RE: Commercial Rezoning with Preliminary Development Plan (PL2022394)

We are responding to your comments dated November 23, 2022, and are submitting with this letter revised plans, and other required documents. Please find the original comments below; our responses are below in bold italics.

PLANNING REVIEW

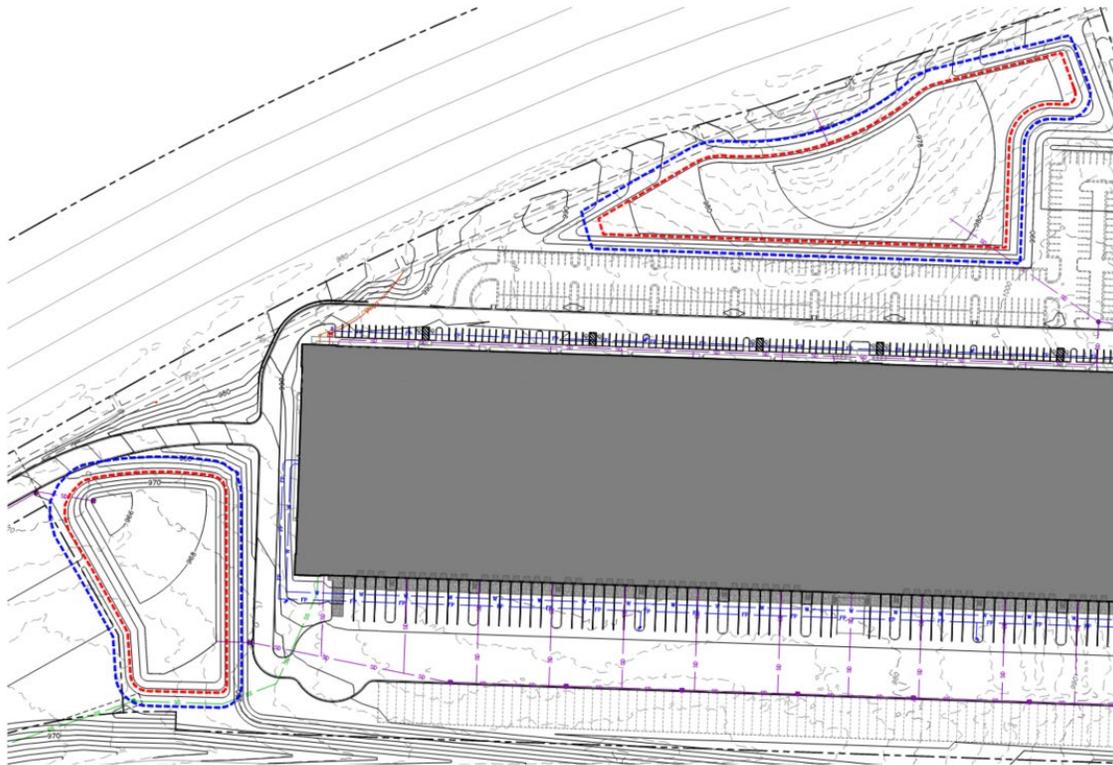
4. Please ensure there is a minimum setback of 20 feet from the clogged condition within the detention basins and any building or property line. It appears this is the case, but please check to make sure.

We confirm that water surface in both basins is at least 20 ft away from any building and property lines in clogged conditions. Refer to a screenshot on the next page. Red dashed lines represent 100-yr water surface elevations at clogged conditions and blue dashed lines are 20-ft offset lines.
